Tanker Q&As and CIs on the IACS CSR Knowledge Centre

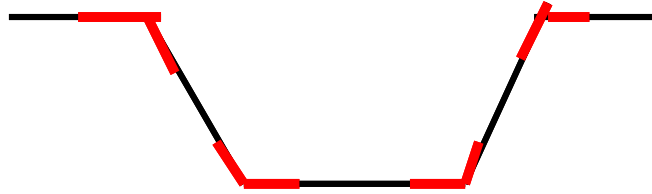
900	6/5.7.4.1	Question	primary support members	2009/4/7	Welding of end connections of primary support members (i.e. transverse frames and girders) is to be such that the weld area, A_{weld} , is to be equivalent to the Rule gross cross-sectional area of the member. In terms of weld leg length, l_{leg} , this is to be taken as by formula. What is the definition of Rule gross cross-sectional area, whether prescriptive requirements area (with reduction to 85%) or the t gross thickness all the rule requirements complying FE analysis (including buckling)? And what is the definition of t p-grs?	t p-grs (Rule gross thickness) is to be taken as the Rule required gross thickness considering all requirements in Section 8,9 and 10	
901 attc	Table 6.5.4	Question	weld factor	2009/4/7	In the Table 6.5.4, the weld factor is selected based on position of 'at ends' and 'remainder'. 'At ends' is considered area where high shear area as the interpretation on Note 1 in Table 6.5.4. Is the weld factor for 'at ends' to be applied for the extremely extruded bracket toe as attachment ? Or is there any other guidance whether 'at ends' or not?	Reduced length for 'at ends' can be accepted for arrangements where large backing brackets are fitted as indicated in our attachment (the T/BHD to L/BHD connection). Hence the weld factors 'at ends' need not extend beyond the toe of the member for this kind of arrangements.	Y

KC#1102

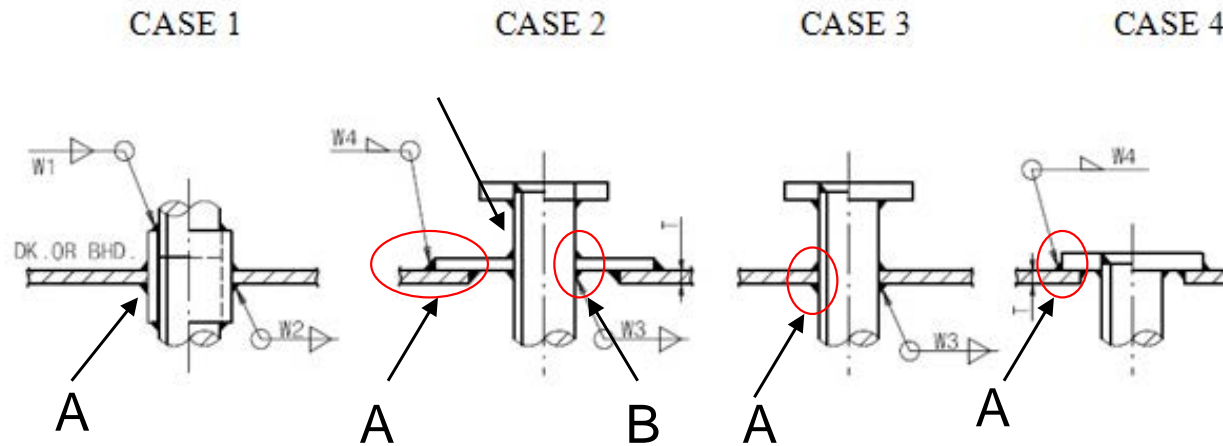
KCID No.	Ref.	Type	Topic	Date completed	Question/CI	Answer	Attachment
1093	Table 6.1.3	Question	Requirement of material class within 0.4L amidships	2011/4/11	<p>Quoted: Table 6-1-3 Note 2 : Single strakes required to be of material class III or E/EH are, within 0.4L amidships, to have breadths not less than $800 + 5L$ mm, but need not be greater than 1800mm. Table 6.1.3, Note 6 : (For Bilge strake only) To be not lower than D/DH within 0.6L amidships of vessels with length, L, exceeding 250m.</p> <p>Unquoted: Question: This width requirement is explicitly applicable to "within 0.4L amidships" in Note 2 and then, it is understood that there is no such width requirement in Note 6. Please confirm.</p>	The width requirement is generally applicable within 0.4L.	
1102 attc	6/5.3.4.3	Interpretation	Clarification for the types of welding on collar plates	2011/7/8	<p>Full penetration welding 6/5.3.4.3: e) edge reinforcements within 0.6L amidships to the strength deck, sheer strake, bottom and bilge plating, when the transverse dimensions of the opening exceeds 300mm, see Figure 6.5.5. Where collar plates are fitted in way of pipe penetrations, the collar plate is to be welded by a continuous fillet weld.</p> <p>Please clarify what type of welding (full or fillet) should be applied for 4 cases (See attachment).</p>	<p>1a) Case 1 (opening is equal or greater than 300mm): A(full penetration welding) -> sleeve can be regarded as an edge reinforcement. (similar situation to the example in Figure 6.5.5)</p> <p>1b) Case 1 (opening is less than 300mm): A(continuous fillet welding)</p> <p>2) Case 2 : A(continuous fillet welding), B(continuous fillet welding)</p> <p>3) Case 3 : A(continuous fillet welding) -> pipe is not an edge reinforcement.</p> <p>4) Case 4 : A(continuous fillet welding)</p>	Y

Case 1 : A(?)

Case 2 : A(?), B(?)

Case 3 : A(?)

Case 4 : A(?)
